Contract #: 04-0120F4Cty: SF/ALA Rte: 80 PM: 13.2/13.9File #: 69.25B**QUALITY ASSURANCE -- NON-CONFORMANCE REPORT****Location:** Changxing Island, Shanghai, P.R. China**Report No:** NCR-000853**Prime Contractor:** American Bridge/Fluor Enterprises, a JV**Date:** 29-Sep-2010**Submitting Contractor:** Zhenhua Port Machinery Company, Ltd (ZPMC), Changxing Island**NCR #:** ZPMC-0815**Type of problem:**

NON-CONFORMANCE REPORT TRANSMITTAL

Dear: Mr. Charles Kanapicki
Attention: Mr. Thomas Nilsson Project/Fabrication Manager
Subject: NCR No. ZPMC-0815

Job Name: SAS Superstructure
Document No: 05.03.06-000810

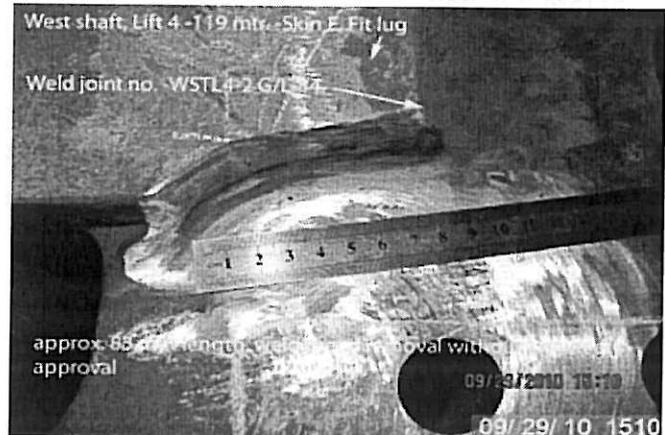
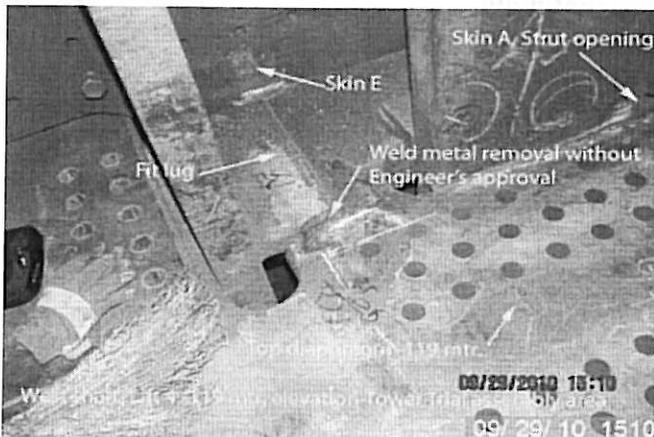
Reference Description: Skin E, Fit lug-119m have been cut without Engineer's approval

- Approximately 85mm in length, (25mm wide) of Fit Lug that was welded to the top diaphragm. Skin Plate E was removed without engineer approval.

- The Fit lug found in top diaphragm, skin E, Lift 4- 119 mtr, West Tower,
- The Weld removed has the following Weld ID: WSTL4-2 C/L-86.

AWS D1.5 Section 3.7.5- "The Engineer shall be notified before improperly fitted and welded members are cut apart."

Contractor submitted TC-RFI-0166 expressing there's an interference between the Tower flange splice plate and a fit lug at the 119M elevation. Conflict required coping the fit lug (55mmX35mm) to allow full contact with the splice plate's faying surface. For future constructability issues, ZPMC will instruct the workers to report to QC first, obtain prior approval from Engineer, and then proceed ahead with the agreed upon resolution.

TC-RFI-0166 response accepted to leave the fit-lug plate cut-out (maximum depth of 35mm as shown) to clear the diaphragm splice plate, provided that the trim was tapered in a 2:1 transition and MT was performed to ensure no cracks after grinding smooth. Work was performed in conformance with TC-RFI-0166, NDT reports received. ZPMC instructed their workers to notify QC immediately whenever there are questions regarding constructability, and can only perform remedial work with prior Engineer's approval.

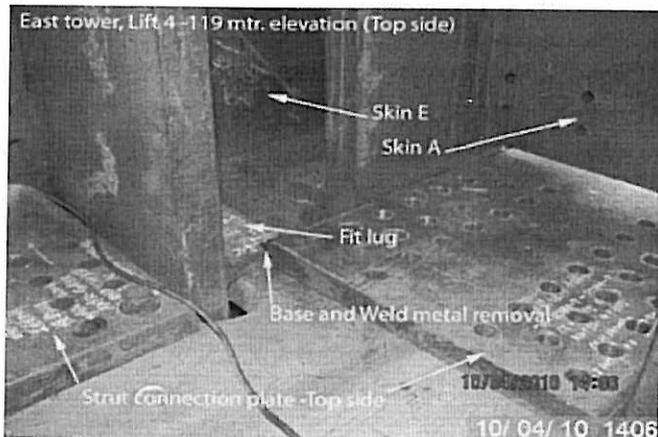
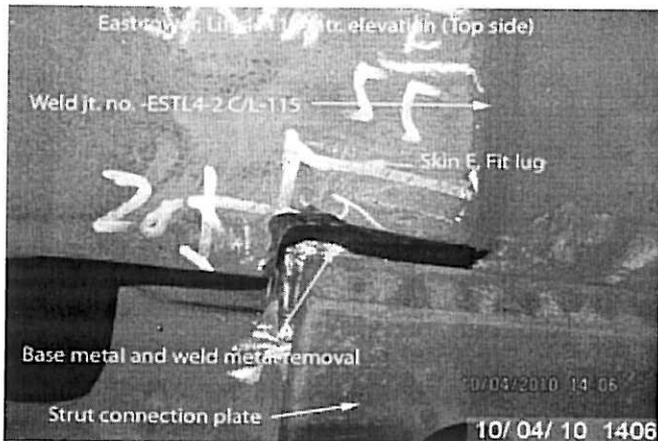
Reference Description: East and North Shaft at 119m: Skin E - Fit Lug removal without Engineer's approval

-Approx. 55 mm length, 25 mm width, weld metal and base metal removal observed in Skin E, fit lug weld without Engineer's approval.

-The fit lug found in East Tower, Lift 4- 119m top diaphragm.

-The weld joint no. of the fit lug weld found to be ESTL4-2 C/L-115.

-Approx. 50 mm length, 35 mm width, weld metal and base metal removal observed in Skin E, fit lug weld without engineer's approval.

-The fit lug found in North Tower, Lift 4- 119m top diaphragm.

-The weld joint no. of the fit lug weld found to be NSTL4-1 C/L-98.

AWS D 1.5 Section 3.7.4 – “Prior approval of the Engineer shall be obtained for repairs to base metal (other than those required by 3.2), repair of major or delayed cracks, repairs to ESW and EGW welds with internal defects, or for a revised design to compensate for deficiencies.”

AWS D1.5 Section 3.7.5- “The Engineer shall be notified before improperly fitted and welded members are cut apart.”

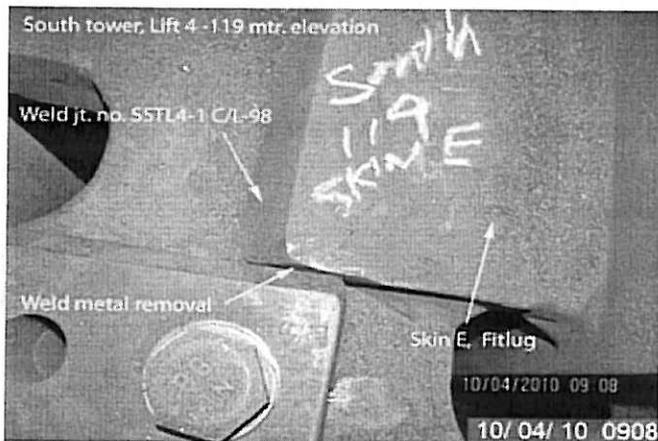
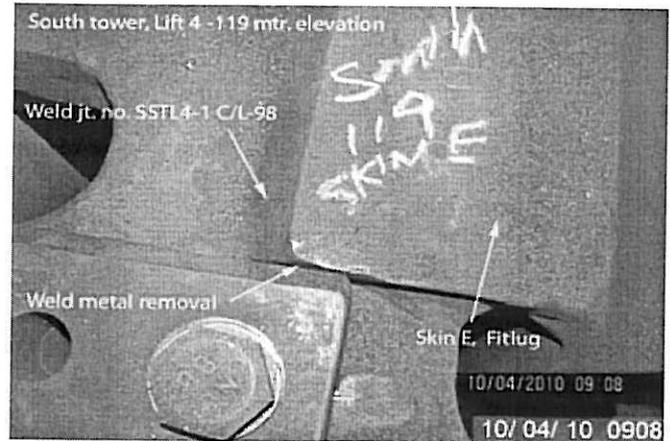
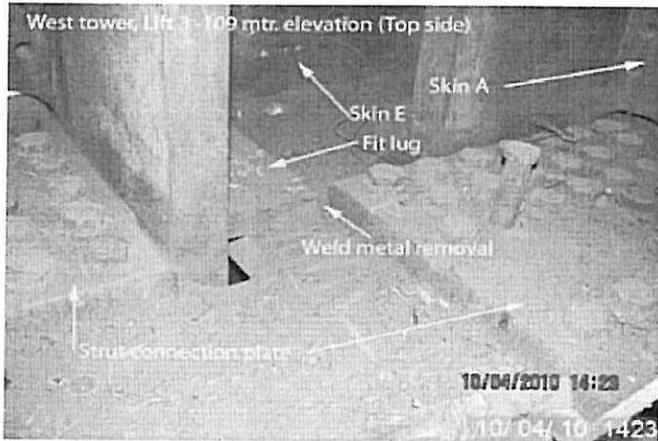
Reference Description: Fit Lug Removal without Engineer's approval located at West Shaft (109m) and South Shaft (119m)

- Approx. 50mm length, weld metal removal observed in Skin E, fit lug weld, without Engineer's approval.
- The fit lug found in West Tower, Lift 3- 109m top diaphragm.
- The weld joint no. of the fit lug weld found to be WSTL3-4 I / K-128.

- Approx. 55mm length, weld metal removal observed in Skin E, fit lug weld, without Engineer's approval.
- The fit lug found in South Tower, Lift 4- 119m top diaphragm.
- The weld joint no. of the fit lug weld found to be SSTL4-1 C/L-98.

AWS D1.5 Section 3.7.5- "The Engineer shall be notified before improperly fitted and welded members are cut apart."
